Arizona Public Service Company

PALO VERDE NUCLEAR GENERATING STATION
P.O. BOX 52034 • PHOENIX, ARIZONA 85072-2034

**Subject: Palo Verde Nuclear Generating Station (PVNGS)
Units 1, 2, and 3
Docket Nos. STN 50-528/529/530
Response to NRC Request for Additional Information on Risk-Informed
Inservice Testing Program**

**NRC Questions and APS Responses Related to
Risk-Informed IST**

Corrective Action/Feedback Mechanism For Risk Informed IST Program

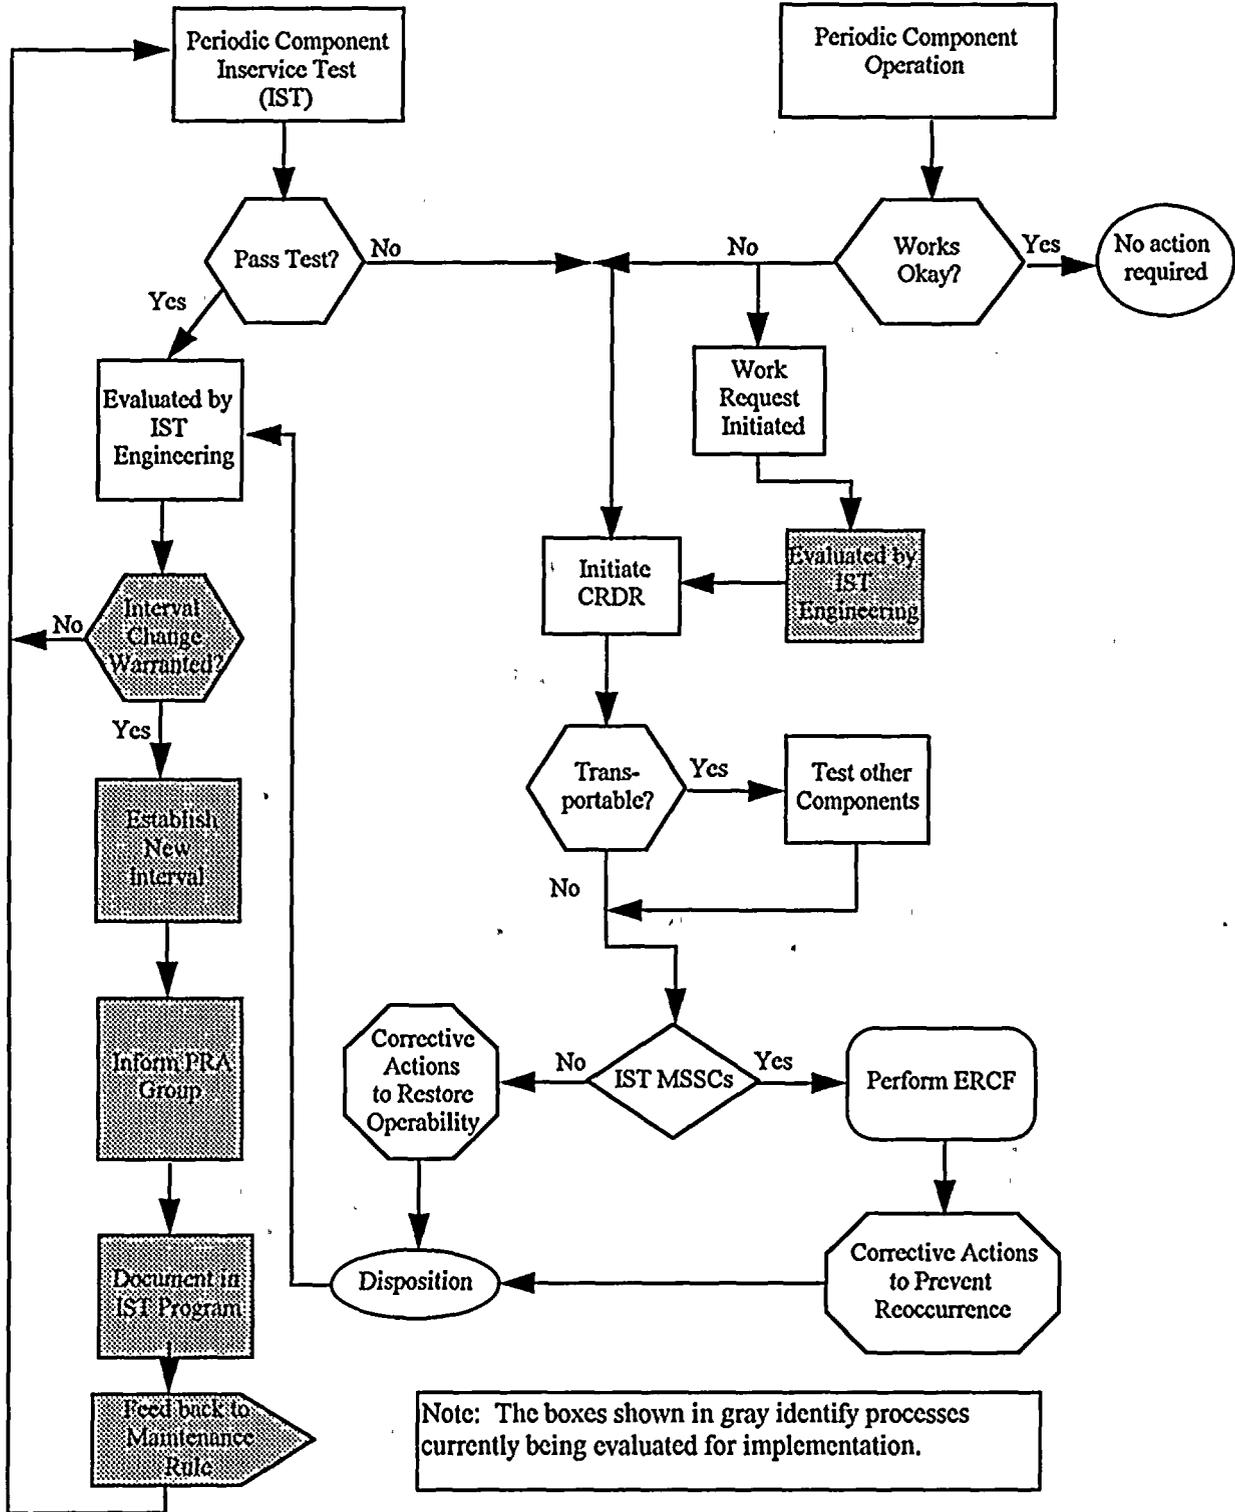
Describe the PVNGS corrective action program that is referenced in Section 2 and exercised in the event that an LSSC fails its inservice test. What criteria would be used to initiate testing of the remaining valves in that group? The corrective action should explicitly include consideration of the need for revising the test frequency. The staff would like to review, during a site visit, any PVNGS procedures or program documents that provide assurance that failures of IST components will be promptly identified and addressed and modifications to the inservice testing program (e.g., changes to the surveillance intervals) are made in a timely manner.

Response:

1. Transportability: A Condition Report / Disposition Request (CRDR) is initiated when a CRDR condition exists. CRDR conditions include premature, repetitive, or unexpected component failures which require additional evaluation. Therefore a CRDR would be initiated whenever a failure occurs. CRDRs are classified as Significant, Adverse, or Review. Failure of a RI-IST component would be classified as Significant or Adverse using the guidelines in the CRDR procedure. It is expected that failure of MSSCs would be classified as significant and failures of LSSCs would be classified as adverse. Significant CRDRs receive a transportability evaluation as part of the root cause investigation to identify other equipment that may experience failures from similar root cause(s) and to ensure that specified corrective actions will be broad enough to prevent this specific failure as well as other susceptible component failures. Adverse CRDR evaluations also address the transportability of the condition, although less rigorously than in a formal root cause investigation. Therefore the CRDR process ensures that failures of components in the RI-IST Program will be evaluated to address the susceptibility of other components to the same failure mechanism and the need for corrective action on other components. Palo Verde is currently evaluating the need to identify any work document generated on the equipment within the scope of the RI-IST program. This may involve the IST engineer screening all work

documents for conditions which may need further evaluation. Further details on this will be provided to the staff by September 30, 1996.

2. The need to adjust test intervals: Because fixed IST test intervals are specified by the Code, the current corrective action program does not address the need to evaluate test intervals after a failure. A new process will be added to the IST Program procedure to evaluate functional failures of IST components for the need to adjust the test intervals. It may use the functional failure reporting mechanism developed for the Maintenance Rule. The evaluations will be done by IST Engineering, which will also initiate any necessary test interval changes. The procedure content to put this process in place will be provided to the staff by September 30, 1996.
